Access Compliance Report

Public Rights-of-Way

(Curb Ramps)

Intersection ID: N/A	Main Street: PERWINKLE_HILL_CT	Cross Street: N/A	Location: S
ADA ID: 8911A69C7DF5	Ramp Type: Perp	Initial Pass/Fail: Fail	Overall Compliance: No
		Severity Score: 25

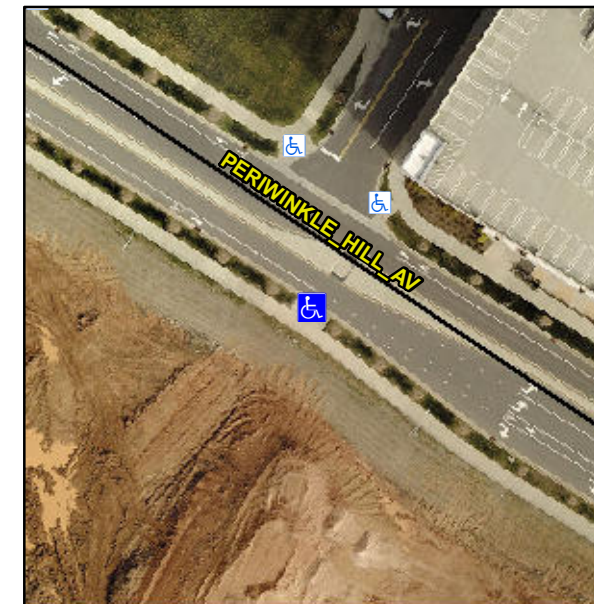
Not Found, R304.5.3

Compliance	Description	Data	Compliance	Description	Data
N/A	Ramp Length (in)	94.0	Yes	Ramp Slope (%)	7.2
Yes	Ramp Width (in)	60.0	No	Ramp XSlope (%)	7.8
N/A	Flare Type LT	N/A	N/A	Flare Type RT	N/A
N/A	Flare Slope LT (%)	N/A	N/A	Flare Slope RT (%)	N/A
N/A	Flare Traversable LT?	N/A	N/A	Flare Traversable RT?	N/A
N/A	Landing Length (in)	N/A	N/A	DWS Provided?	N/A
N/A	Landing Width (in)	N/A	N/A	DWS Contrast?	N/A
N/A	Landing Slope (%)	N/A	N/A	DWS Length (in)	N/A
N/A	Landing X Slope (%)	N/A	N/A	DWS Full Width?	N/A
N/A	Landing Curb? (Y/N)	N/A	N/A	DWS Offset (in)	N/A
N/A	Shared Landing?	N/A			
N/A	Gutter Ponding?	N/A	N/A	Gutter Slope (%)	N/A
N/A	Gutter Lip Ht (in)	N/A	N/A	Gutter X Slope (%)	N/A
N/A	Painted X Walk1?	No	N/A	Painted X Walk2?	N/A
	X Walk 1 Direction	To NE		X Walk 2 Direction	N/A
N/A	X Walk 1 Width (in)	N/A	N/A	X Walk 2 Width (in)	N/A
	X Walk 1 Slope (%)	2.4		X Walk 2 Slope (%)	N/A
	X Walk 1 X Slope (%)	4.3		X Walk 2 X Slope (%)	N/A

Remove & Replace Entire Ramp.
